MCLEOD FAMILY DIVISION SUBDIVISION

APPLICATION NUMBER 3 DATE August 16, 2018

APPLICANT McLeod Family Division Subdivision

REQUEST Subdivision

DETAIL SITE PLAN

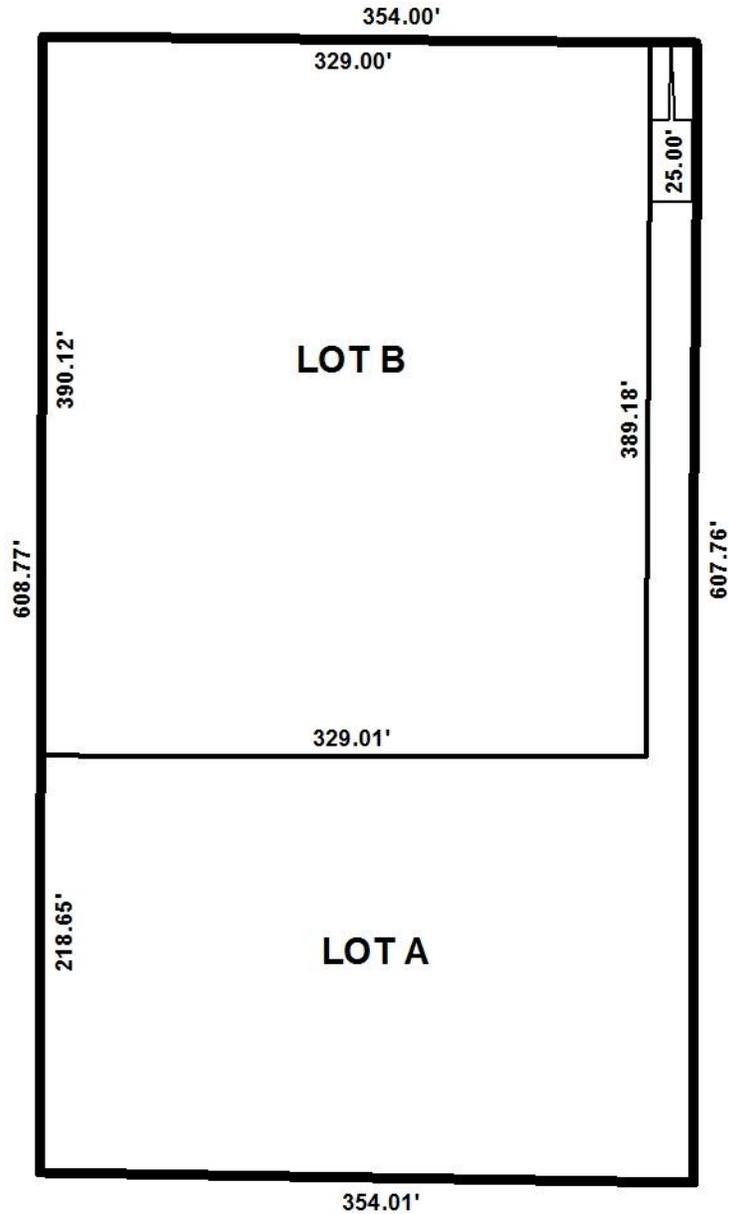
The 25' minimum building setback is not illustrated on the preliminary plat, as required by Section V.D.9. of the Subdivision Regulations. As such, revision of the plat to illustrate the 25' minimum building setback along Seaman Drive where each lot is at least 60' in width should be required, if approved.

Irrespective of the design of the lots, they each meet the minimum size requirements for lots served by public water and individual septic systems; however, their sizes are labeled only in acres and not in square-feet. As such, revision of the plat to indicate the size of each lot in both square-feet and acres should be required, if approved; or, provision of a table on the Final Plat providing the same information may suffice.

The vicinity map on the preliminary plat is hand drawn and may not properly reflect the location of the proposed subdivision. As such, revision of the vicinity map to properly identify the location of the proposed subdivision should be required, if approved.

A Warranty Deed was submitted by the applicant establishing reservation of the right-of-way for the private Seaman Drive, but no information was submitted establishing McLeod Lane.

Additionally, no information proving access to either private road is limited to family members of the respective lots to which each private road has access was submitted.

- 1) the subdivision does not comply with Section VIII.D. of the Subdivision Regulations as the proposed plat would exceed the number of lots (5) allowed on a private road for a family division; and,*
- 2) the existing lots on the private roads are not all owned by family members.*
